PRAIRIE RIDGE ESTATES, SEDGWICK COUNTY, KANSAS

Re: S/D 98-53 -- Final Plat of PRAIRIE RIDGE ESTATES ADDITION

STAFF REPORT

CASE NUMBER: S/D 98-53 - PRAIRIE RIDGE ESTATES ADDITION

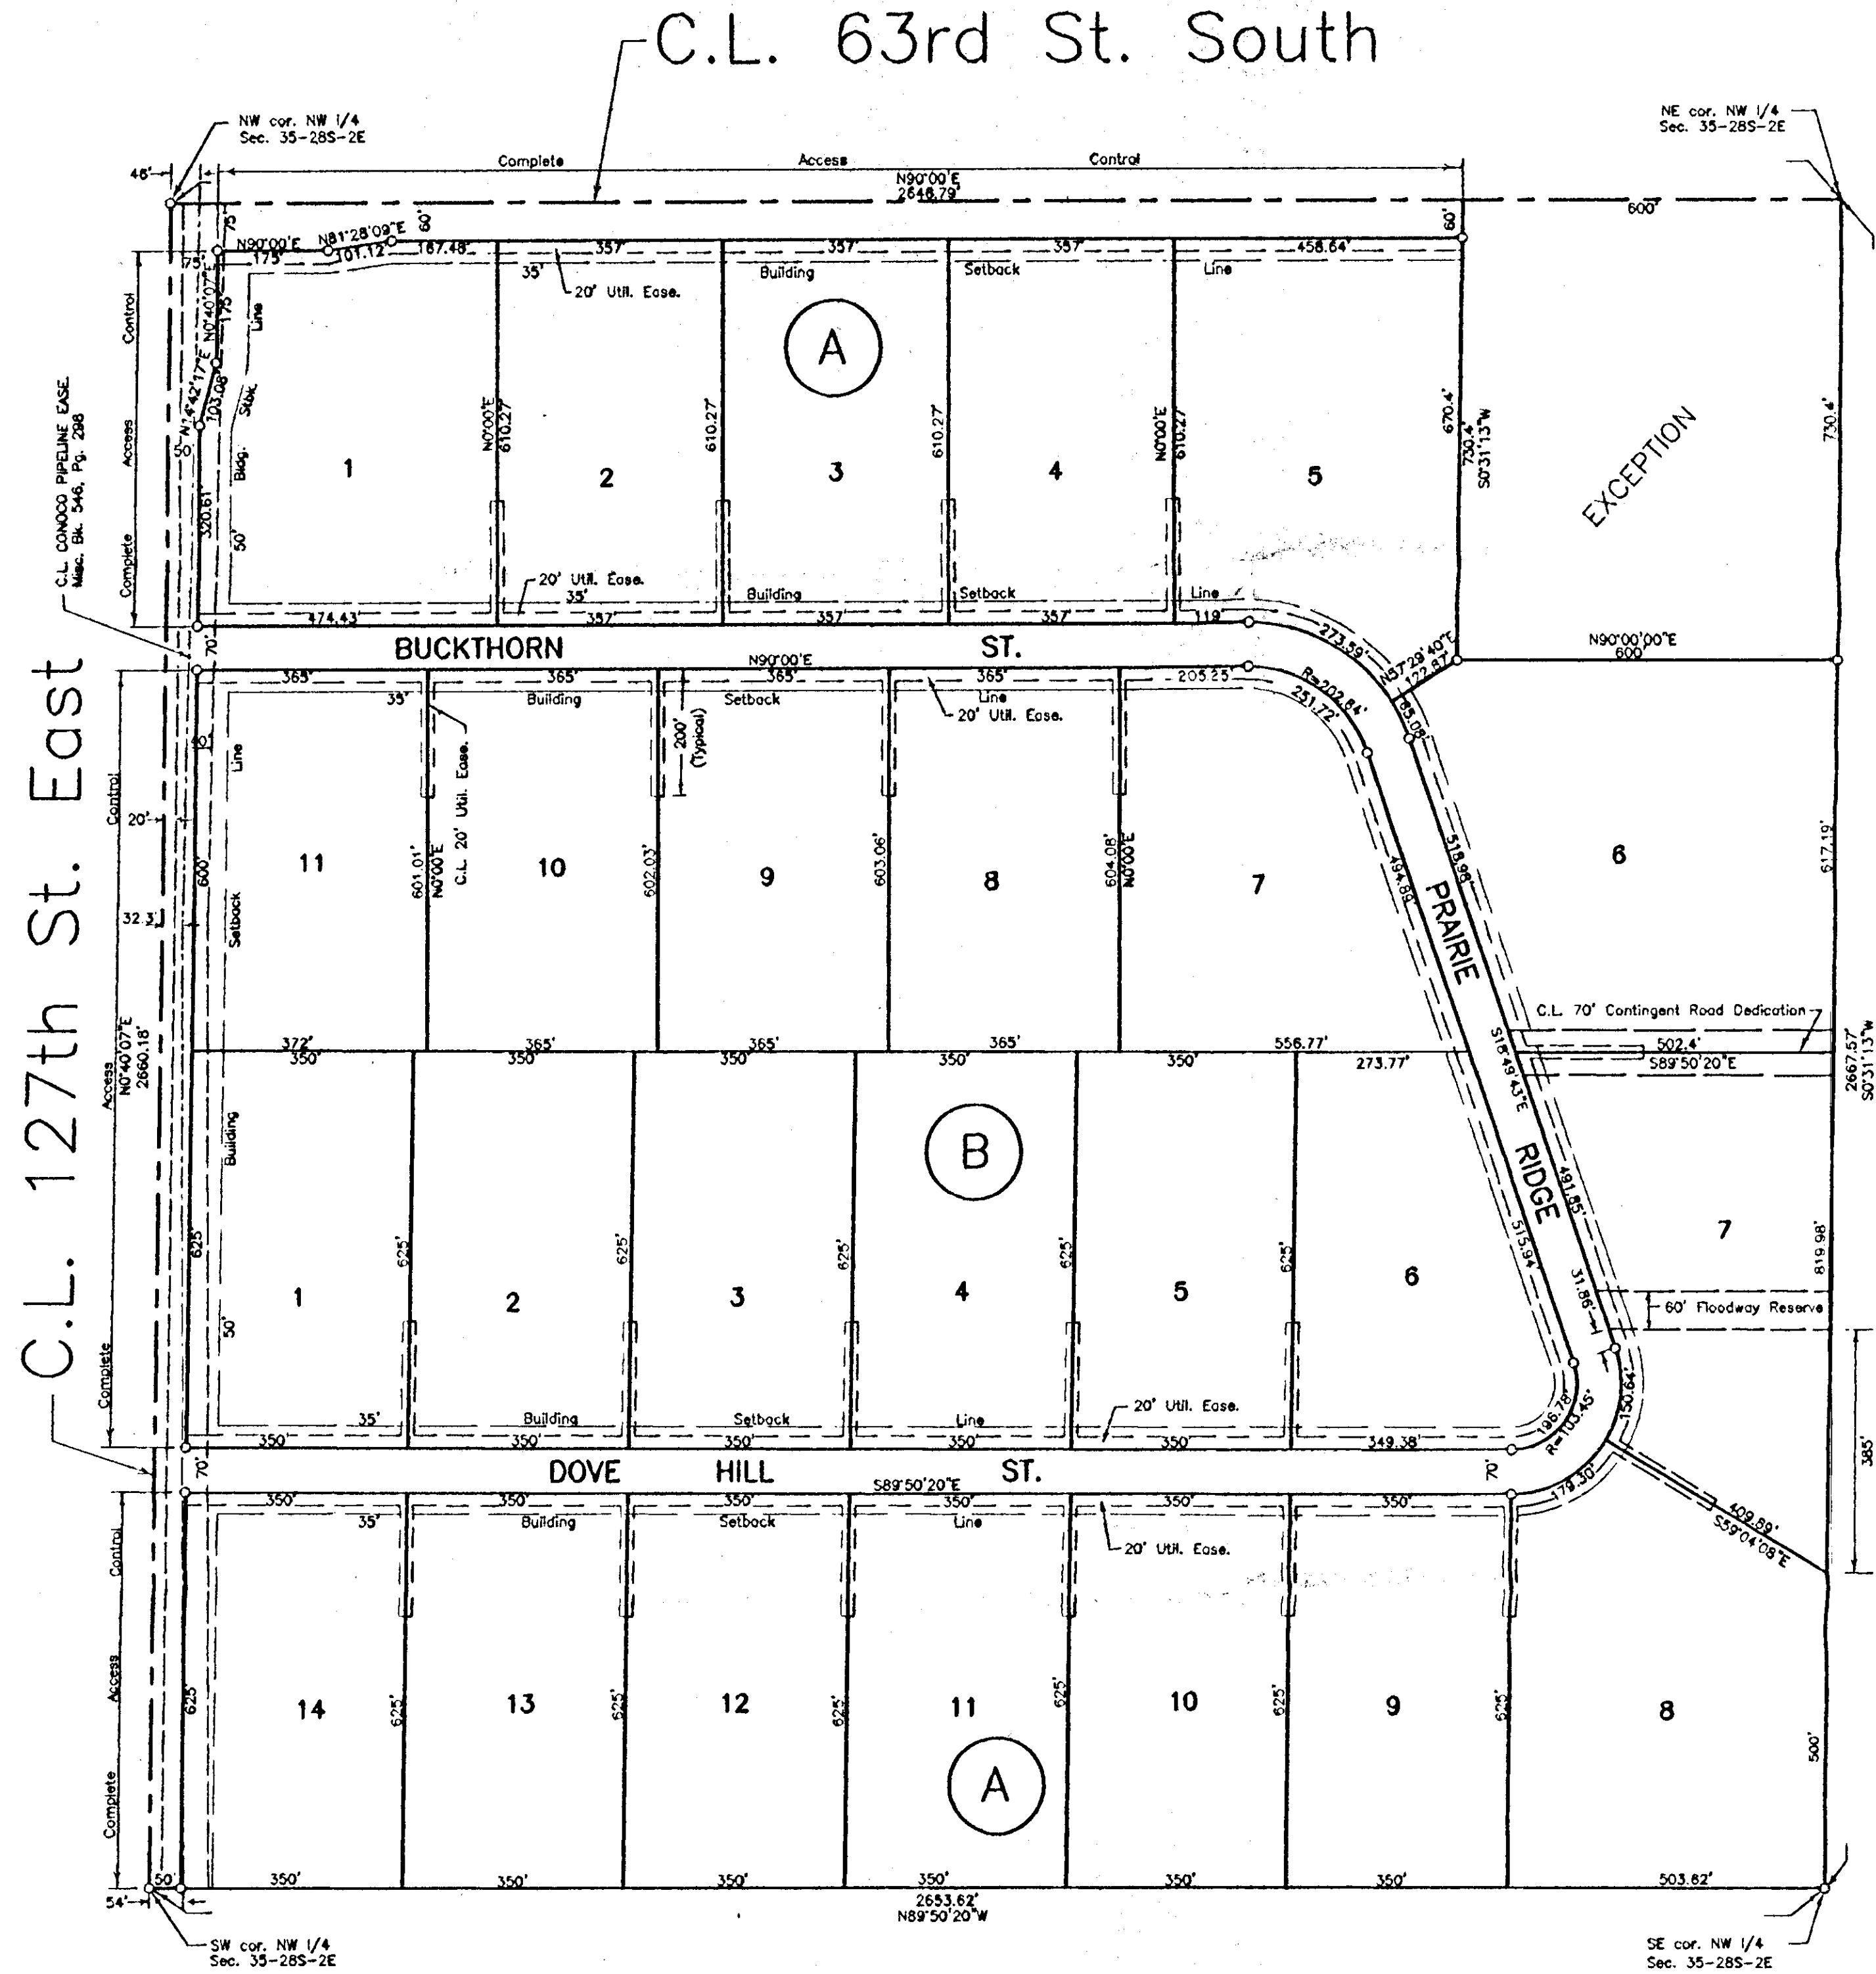
- D. County Engineering needs to comment on the status of the applicant's drainage plan. ***Floodway reserves will need to be platted to cover cross-lot drainage. County Engineering requests the floodway reserve in Lot 7 to be increased in width from 40 feet to 60 feet.***

- E. The applicant shall guarantee the installation of the proposed interior streets to the 32-ft sand road standard.
- F. Complete access control shall be dedicated along the site's frontage to 63rd St. South and 127th St. East. On the final plat, the dedication of access controls shall be referenced in the plat's text.

H. Contingent right-of-way dedications extending to the south and east line of the plat is recommended in order to provide potential street connections. These dedications shall be referenced in the plat's text as being effective upon the platting of any adjacent subdivision having a street connecting thereto. *Applicant explained the existence of 10-acre developed lots to the south; but agreed to plat a contingent right-of-way dedication to the east.*

I. County Engineering needs to comment on the need for improvements to perimeter streets or additional right-of-way. *An additional 10 feet of half street right-of-way needs to be dedicated along the north line of the plat.*

L. County Engineering should comment on the length of the cul-de-sac (2,100 ft.) which exceeds the 1,200 ft. standard. *County Engineering recommends that the southern cul-de-sac be looped northward and connected to the northern street.*

The requested access controls have been depicted on the final plat.

The Subdivision Committee required the platting of the contingent right-of-way dedication to the east on the final tracing.

The requested 10-feet of half-street right-of-way has been denoted on the final plat.

The requested loop street has been denoted on the final plat.
